**Request**  
**Project Name**  
**Council District**  
**Requested by**

**DTC Modification**  
**13<sup>th</sup> & McGavock**  
19 – O’Connell  
Rajesh Aggarwal, with McGavock Street Partnership  
Lesley Beeman, Jr., AIA, with Manuel Zeitlin Architects

## Downtown Code DRC Meeting of 12/6/2018

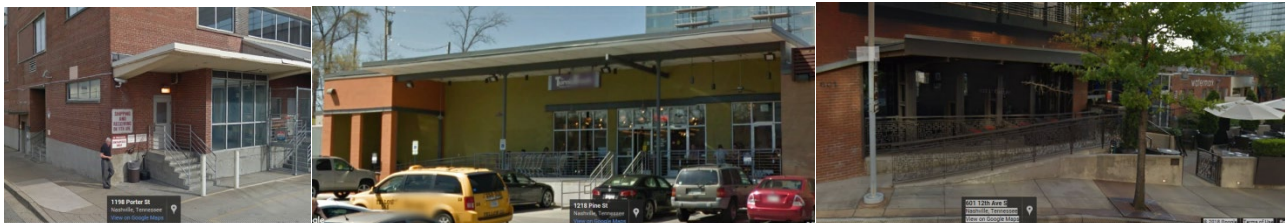
1. Canopies: Canopies shall not be permitted above windows. The applicant is proposing a canopy over the ground floor level above windows and wrapping the corner of the building.

Examples of horizontal canopies may be found throughout the Gulch Subdistrict and is a common element attributed to former industrial and utilitarian buildings. While the canopy standard is appropriate in a context with more traditional and historical elements, the use of a canopy in this instance does not appear to detract from the environs of the Gulch and is in keeping with the general aesthetic of the area.

Furthermore, the proposed canopy serves as a defining element to anchor the corner. The canopy is functions as a roof structure over an outdoor seating area at the corner of 13<sup>th</sup> and McGavock Streets and offers cover for patrons of cab, tour bus, and ride hailing services to await their rides out of the weather.

Planning staff recommends approval for the modification of the canopy standard with the following conditions.

1. Approval is subject to Public Works review and recommended clearance for canopy structures within the public right-of-way.
